NATIONAL DAM SAFETY PROGRAM, PIEDMONT GERIATRIC HOSPITAL DAM (I--ETC(U)

Name of Dam: Piedmont Geriatric Hospital Dam

PHASE I INSPECTION REPORT NATIONAL DAM SAFETY PROGRAM

February 1981

Plate 1: Field Sketch

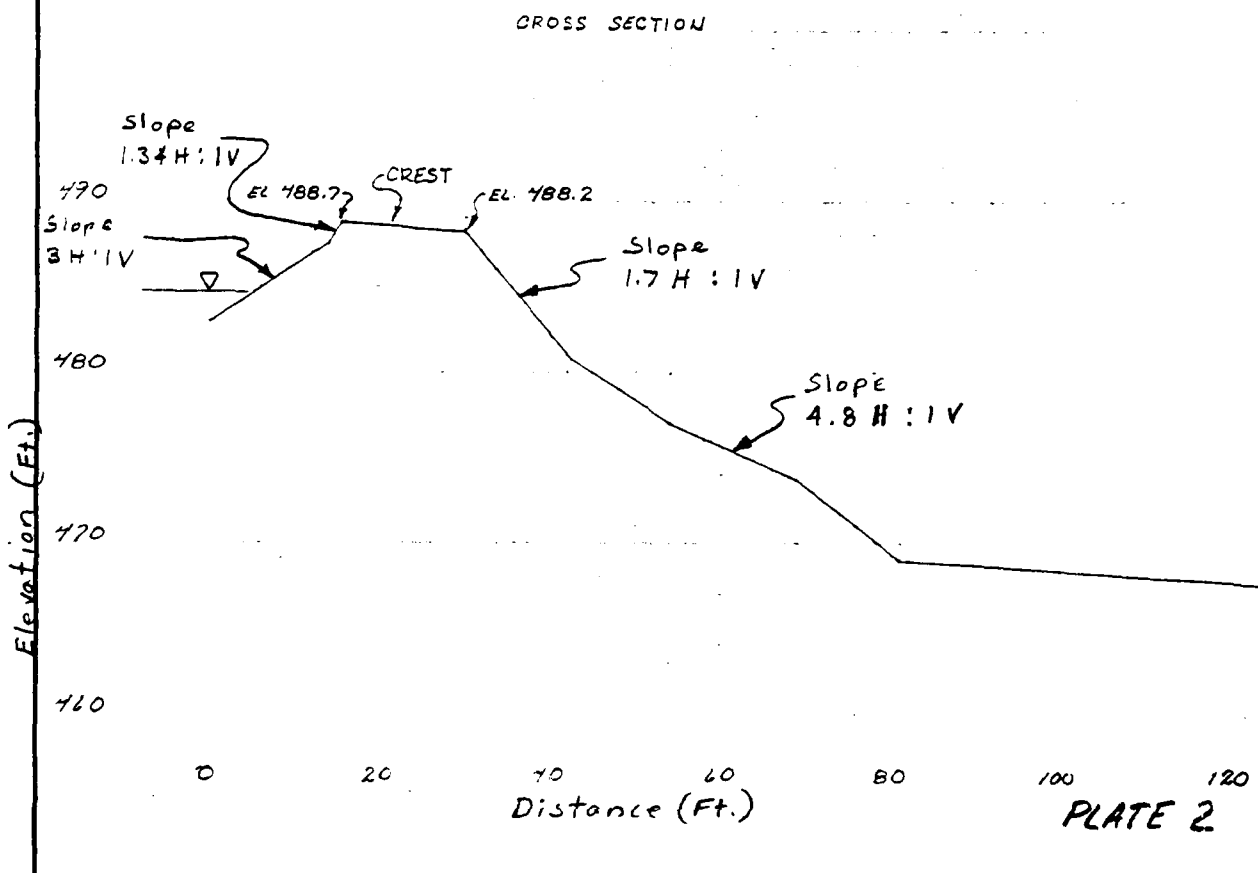
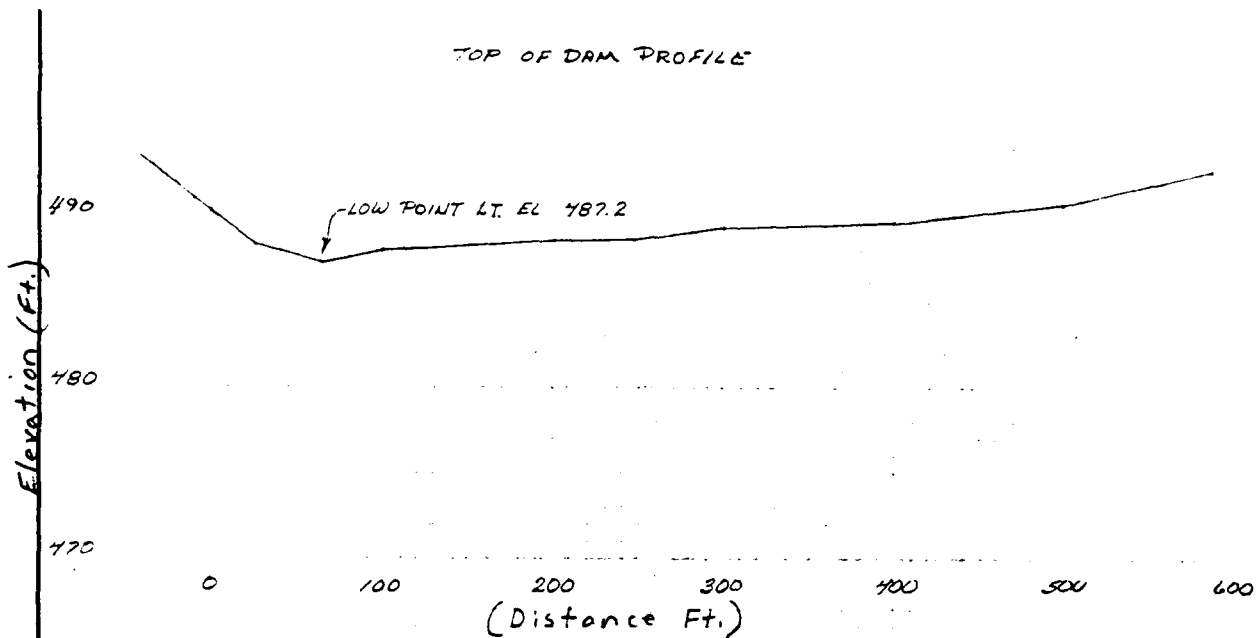
The deficiencies noted during the field inspection are described in the following paragraphs. The complete field compiled descriptions are included in Appendix III. A field sketch depicting existing conditions is included as Plate 1 in Appendix I.

PHOTO 1. Principal Spillway Inlet, Emergency Gate Control

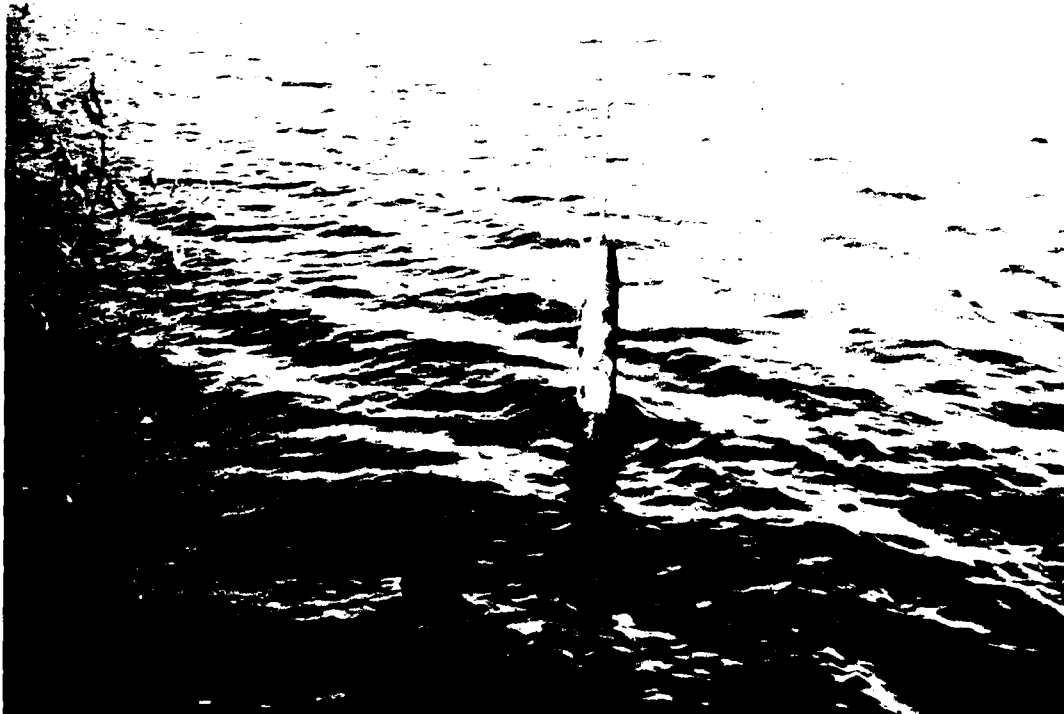
3.1.3 Appurtenant Structures: The inlet of the principal spillway consists of a vertical, open-ended, 6 inch diameter cast iron pipe. No trash rack was provided (Photo 1). The owner's representative reports that this inlet is largely obstructed with rocks that were thrown into the inlet in the past. An emergency valve or gate control is located immediately upstream of the principal spillway inlet. This drain discharges into the principal spillway inlet, and is not operational because the inlet is obstructed with rocks. The outlet of the principal spillway is piped approximately 40 feet downstream of the toe of the embankment before being discharged (Photos 2 and 3).

- 3) Remove obstructions from the principal spillway or replace the spillway.
- 4) Install a trash rack on the crest of the riser of the principal spillway to prevent future blockage.
